***MODIFICATION REQUEST:
Site 4B, Sydney Olympic Park
(MP06_0273 MOD 3)***

Director-General's
Environmental Assessment Report
Section 75W of the
Environmental Planning and Assessment Act 1979

December 2012

Figure 4: Basement B1 Plan

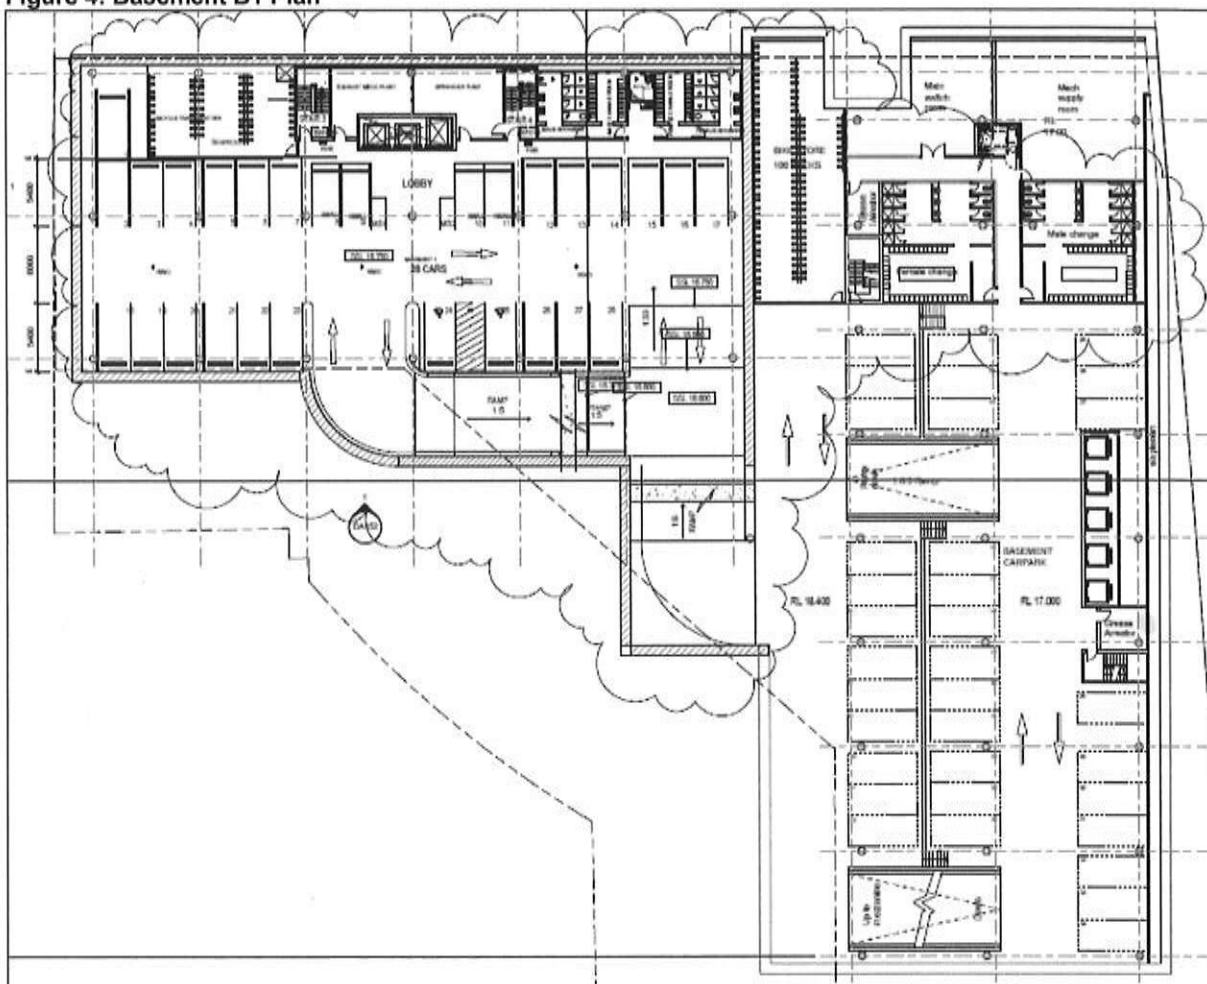
The modifications proposed under MOD 3 will not impact on the number of parking spaces provided or the accessibility of the site or development. The proposed northern basement will accommodate 71 car spaces and 58 bicycle parking spaces, and to ensure consistency with the approved development, 202 car spaces and 100 bicycle parking spaces have been retained for the southern building.

The approved loading bay forms part of the southern building and will not be constructed within the first stage of development. However, a temporary at-grade loading / unloading area will be provided adjacent to the southern elevation of the northern building. This area will provide an opportunity for delivery vehicles to be parked without blocking the proposed driveways whilst being loading and unloaded. This area will also enable delivery vehicles to enter and exit the site, onto Herb Elliot Avenue, in a forward direction (see Figure 4 for basement B1 plan and Figure 5 for the ground floor plan for the northern building showing the driveway entry and loading dock).

Figure 5: Ground floor plan (northern building)

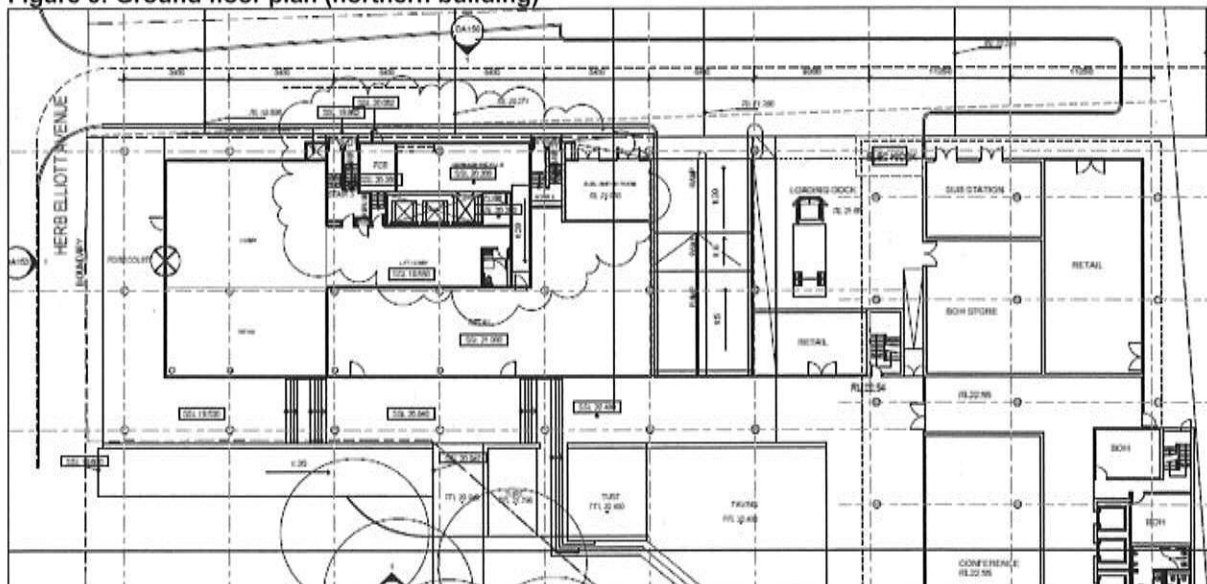
A service corridor has been incorporated into the ground floor design of the northern building so that service access can be provided to the rear of retail space. This redesign has been undertaken to satisfy SOPA's requirements for service access thereby avoiding impacts to the streetscape and public domain.

Figure 6: Additional tree proposed for removal (dotted blue)

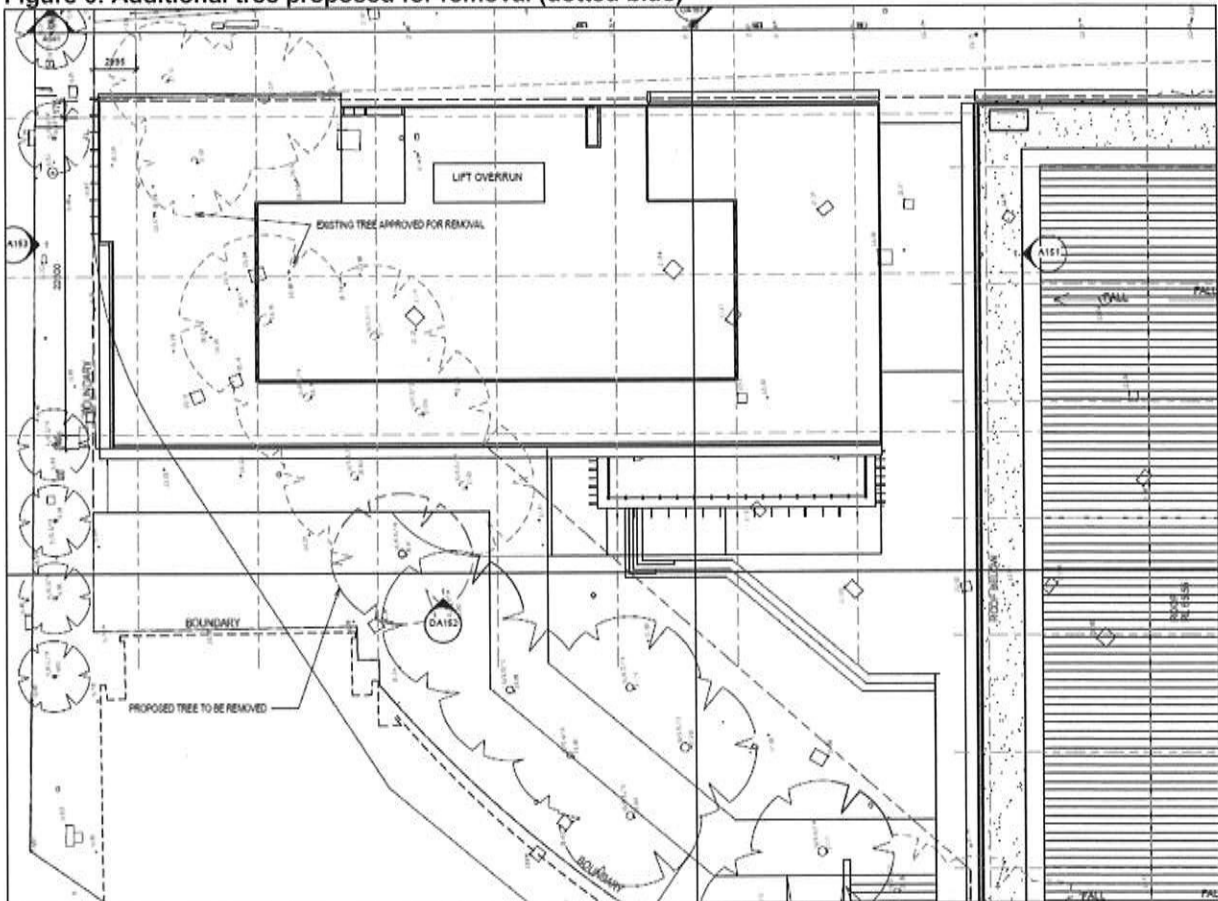
Landscaping in the public domain will still be required to be in accordance with the landscape plans approved as part of MOD 1, which are not proposed to be amended as part of this modification application. However, one additional Brushbox tree may need to be removed as a consequence of the impact of the northern building basement on the root structure of the tree (see Figure 6). This tree was one of 22 Brushbox trees approved for removal in the original approval (MP06_0273), however MOD 1 reduced this number to 17 trees and this tree was proposed to be retained in the MOD 1 approved landscape plans.

The proponent has agreed to remove this tree and replace it elsewhere on the site, within the public domain. A new condition is recommended accordingly. In this regard, the number of trees proposed to be removed remains at 17 as per MOD 1, with the approved landscape plans remaining unchanged in the instrument of approval.
